Re: Fill-related questions from the May 2023 CAG Meeting

Below please find responses to the questions that DDC and HNTB/LiRo received after the May 2023 CAG Meeting related to fill and fill operations for ESCR Project Area 1 in East River Park.

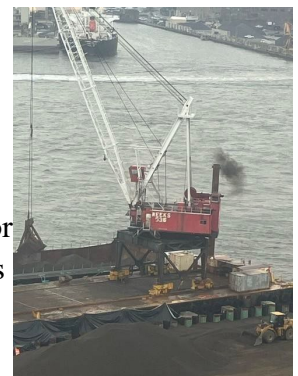
- 8) **Please describe the process for settling; what machinery and techniques are used? How much water or chemicals are being added to the fill in the process?**

DDC Response: As mentioned above, settlement will be monitored and measured until the rate indicates negligible settlement. The wick drains help remove the pore water from soft compressible soils which

aids in soil settlement. As the fill is placed it is compacted in lifts by machinery until the specified compaction density is reached. No chemicals are used as part of the settlement or compaction processes. For the type of material being embanked typically the Contractor will use a single smooth drum vibratory roller for compaction (see example photo below).
